1 Q. At page 12 of Hydro's report "Upgrade Transmission Line Corridor" dated April 28,  
2 2014, Hydro states that "*As the current power system is also unable to remain*  
3 *stable with a similar three phase fault at Holyrood, it was decided to not by to*  
4 *prevent this condition when completing the present analysis as the system is still*  
5 *susceptible to only one location where a three phase fault is of concern. Due to the*  
6 *generally concentrated physical location of the major generation source (BDE)*  
7 *within the electrical grid, this has been accepted as the cost to mitigate would be a*  
8 *major capital expense. "*

**Figure 1 - Peak Case - Relative Rotor Angles following Three-Phase Fault at BDE with Three SOP Synchronous Condensers in Service**

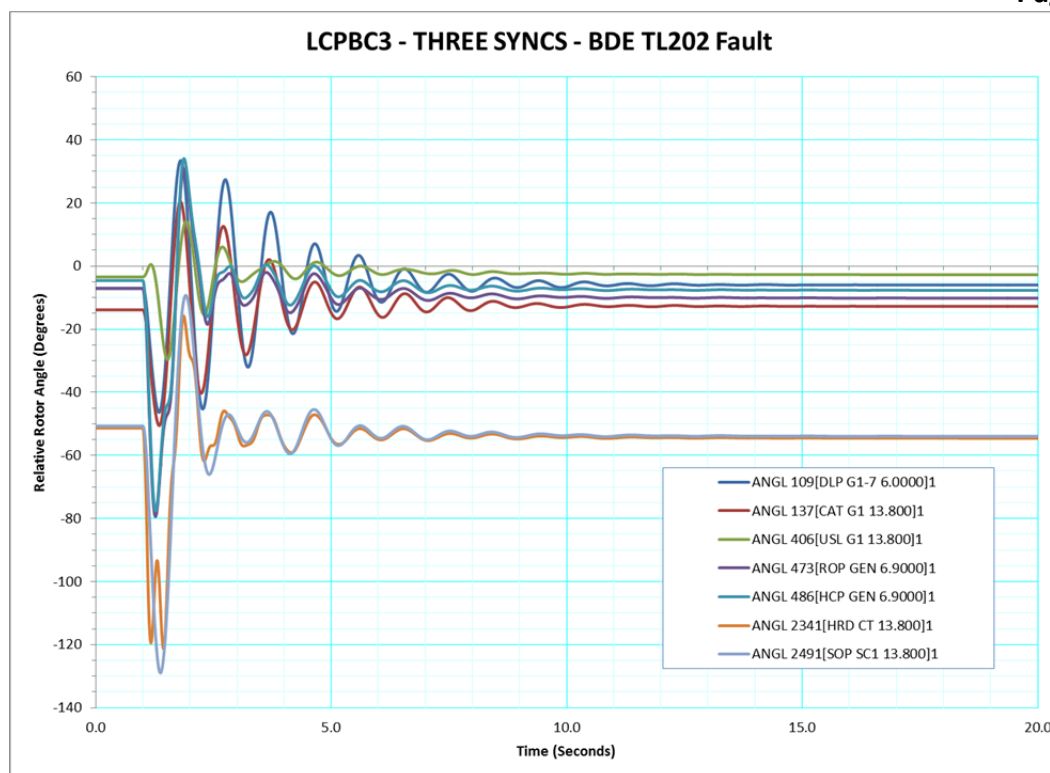
9 Please explain if the foregoing unmitigated circumstance will continue to exist  
10 following completion of the proposed transmission line project.

23 As indicated in the figure below, system stability is maintained in the event of a  
24 three-phase fault at Bay d'Espoir under peak load conditions when all three Soldiers  
25 Pond synchronous condensers are online.

- 1 The System Planning Criteria requires that the system be able to operate assuming
- 2 one synchronous condenser is out of service at Soldiers Pond to firstly, ensure these
- 3 critical units can be maintained and secondly, that in the events of a forced outage,
- 4 system performance would not be adversely impacted. Hydro would plan to
- 5 perform maintenance on the Soldier's Pond synchronous condensers during off
- 6 peak periods to have them available to dispatch to ensure the reliable operation of
- 7 the system during peak periods. In winter months or during severe weather events,
- 8 all three synchronous condensers may be brought online to enhance system
- 9 security and mitigate the impact of the Bay d'Espoir three-phase fault.
